Economic Commission for Europe**Inland Transport Committee****World Forum for Harmonization of Vehicle Regulations****Working Party on Lighting and Light-Signalling****Eightieth session**

Other UN Regulations: UN Regulation No. 10 (Electromagnetic compatibility)**Proposal for the 06 series of amendments to UN Regulation No. 10 (Electromagnetic compatibility)****Submitted by the Task Force on Electromagnetic Compatibility (TF EMC)***

Appendix 5, figure, amend to read:

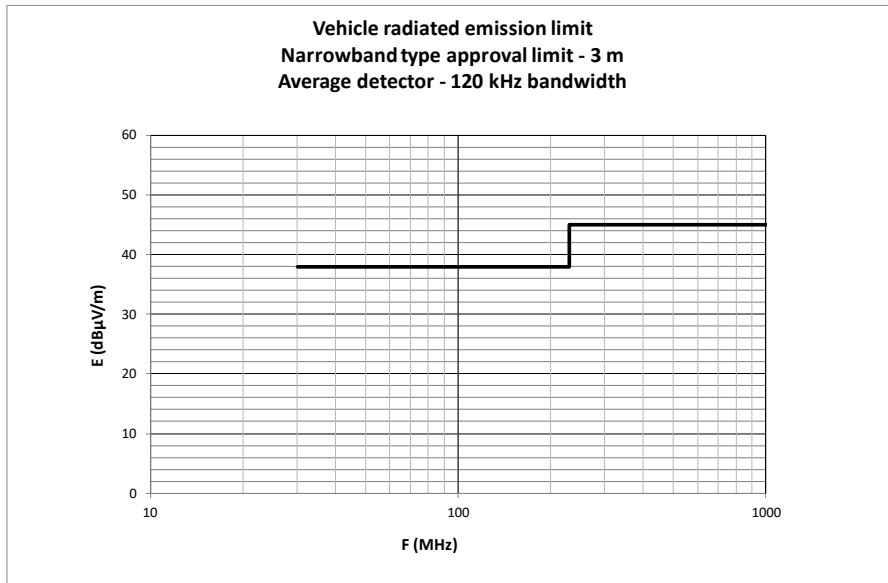
Frequency - megahertz - logarithmic
(See paragraph 6.3.2.2. of this Regulation) "

Figure 3e

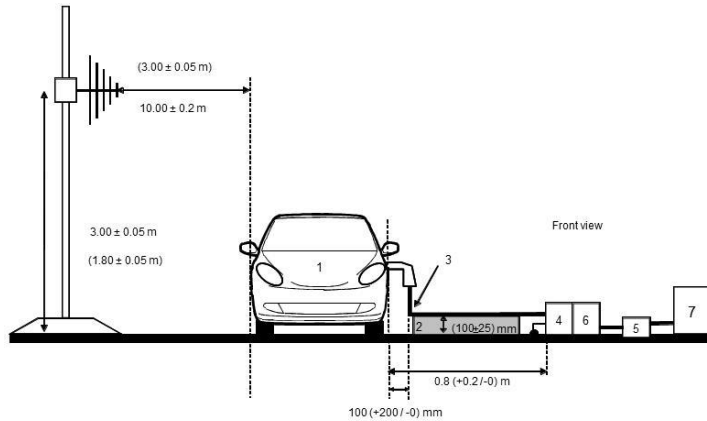
Example of test setup for vehicle with socket located on vehicle side (charging mode 3 or mode 4, with communication)

- 1 Vehicle under test
- 2 Insulating support
- 3 Charging ~~communication~~ cable harness with local/private communication lines
- 4 AC or DC artificial network(s) AMN(s) or DC-charging-AN(s) grounded
- 5 Power mains socket
- 6 Impedance stabilization(s) AAN(s) grounded (optional)
- 7 Charging station

Figure 3g

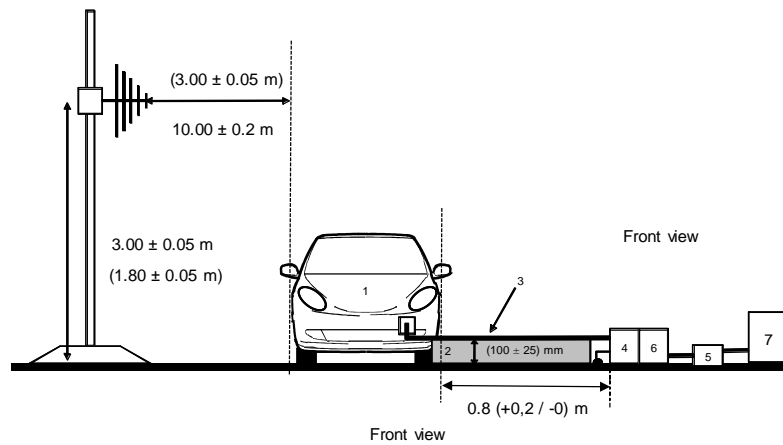
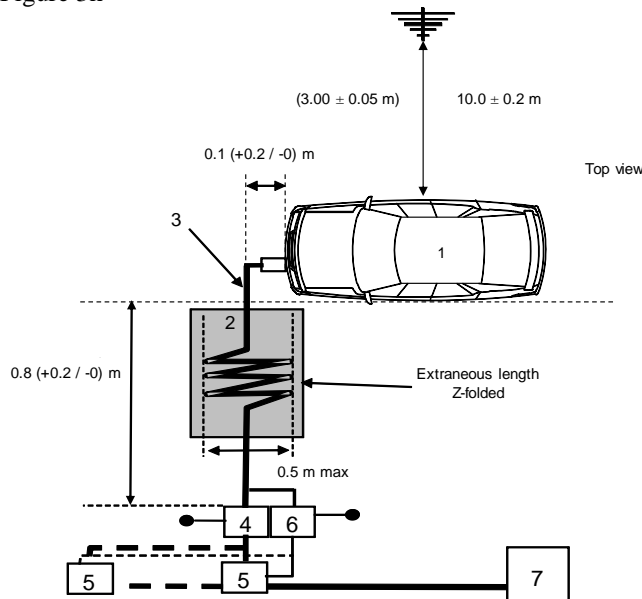
- 1 Vehicle under test
- 2 Insulating support
- 3 ~~Charging cable~~ **Charging cable harness with local/private communication lines**
- 4 ~~AC or DC artificial network(s) AMN(s) or DC-charging-AN(s) grounded~~
- 5 Power mains socket
- 6 ~~Impedance stabilization(s) AAN(s) grounded (optional)~~
- 7 "Charging station"

Figure 4

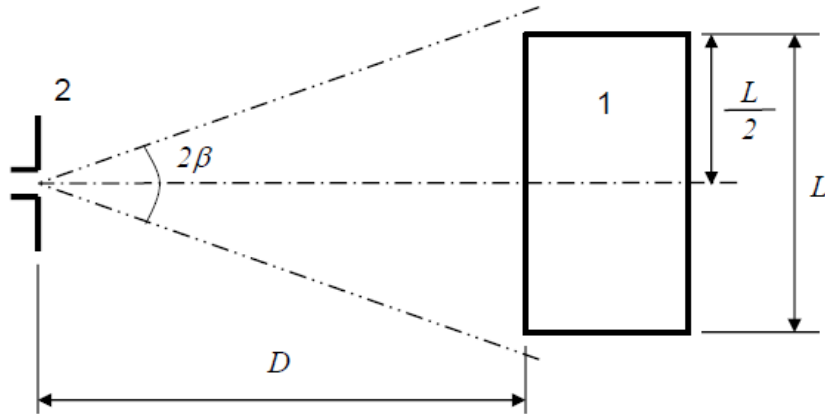
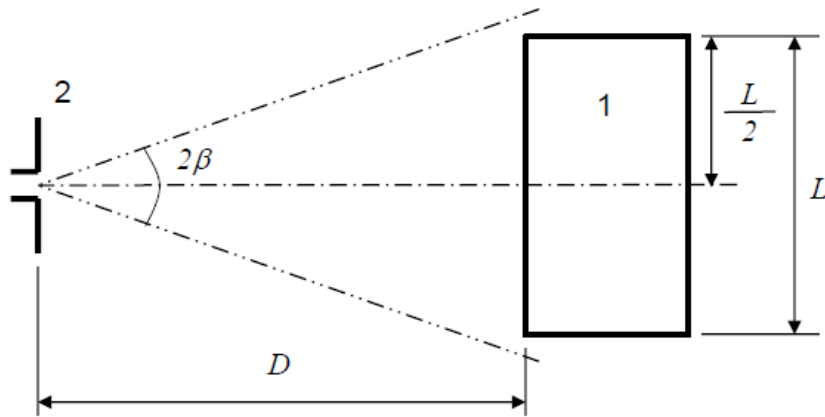
- if the length of the vehicle is smaller than the 3 dB beamwidth of the antenna, only one antenna position is necessary. The antenna shall be aligned with the middle of the total vehicle (see Figure 4)

- **If the length of the vehicle is smaller than the 3 dB beamwidth of the antenna, only one antenna position is necessary. The antenna shall be aligned with the middle of the total vehicle (see Figure 4)**

Figure 5

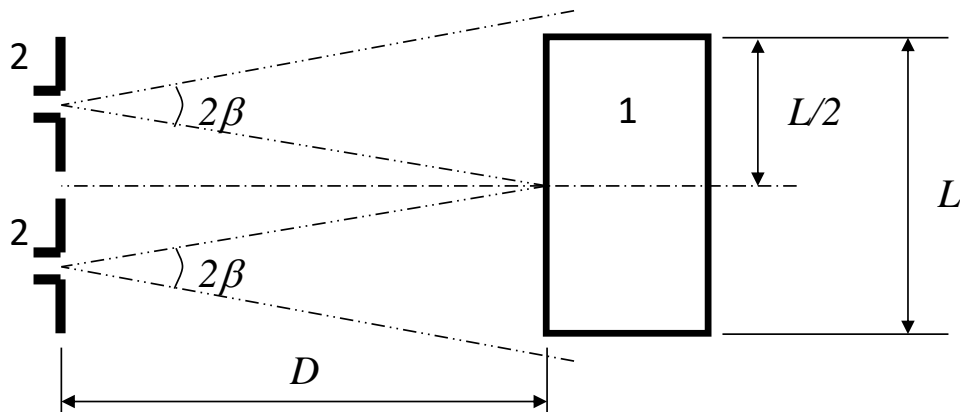
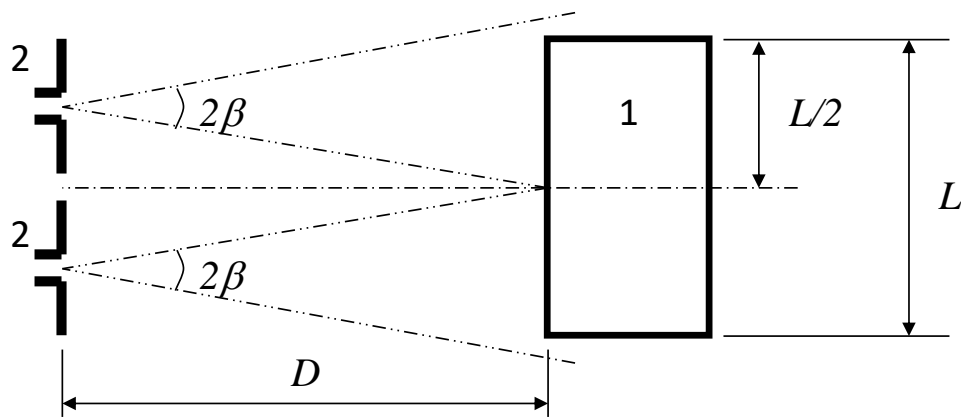
- if the length of the vehicle is greater than the 3 dB beamwidth of the antenna, multiple antenna positions are necessary in order to cover the total length of the vehicle (see Figure 5). The number of antenna positions shall allow to meet the following condition:

if N>1 (more than one antenna position is necessary) and multiple antenna positions are necessary in order to cover the total length of the vehicle (see Figure 5). The antenna positions shall be symmetric in regard to the vehicle perpendicular axis."

Figure 1
ESA in configuration "REESS charging mode coupled to the power grid" (floor-standing equipment)

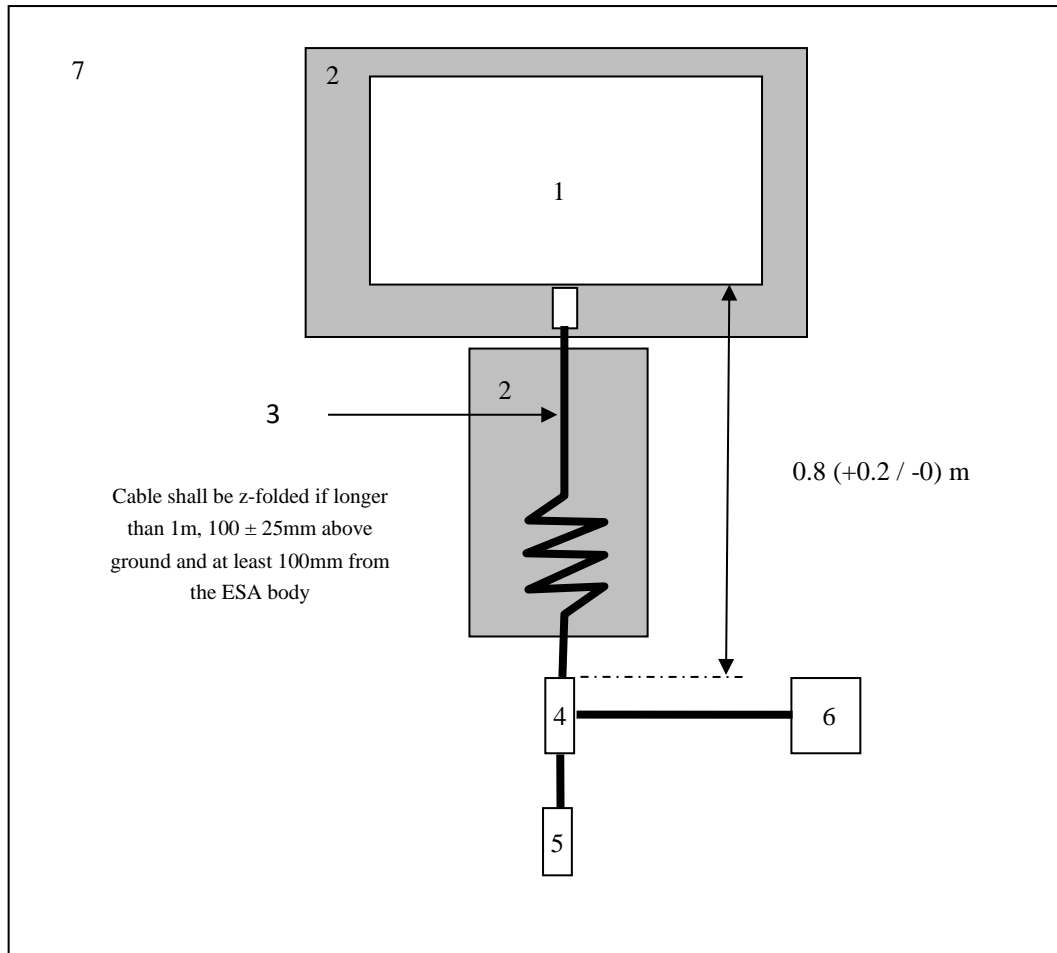
"3.3. The test set-up (**floor-standing equipment**) for the connection of the ESAs in configuration "REESS charging mode coupled to the power grid" is shown in Figure 1 of Appendix 1 to this annex."

Figure 1

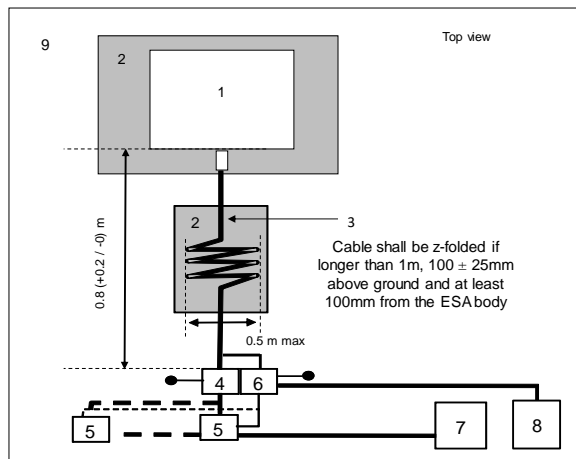
"3.3. The test set-up (**floor-standing equipment**) for the connection of the ESA in configuration "REESS charging mode coupled to the power grid" is shown in Figure 1 of Appendix 1 to this annex."

Annex 20, Appendix 1, delete and replace by:
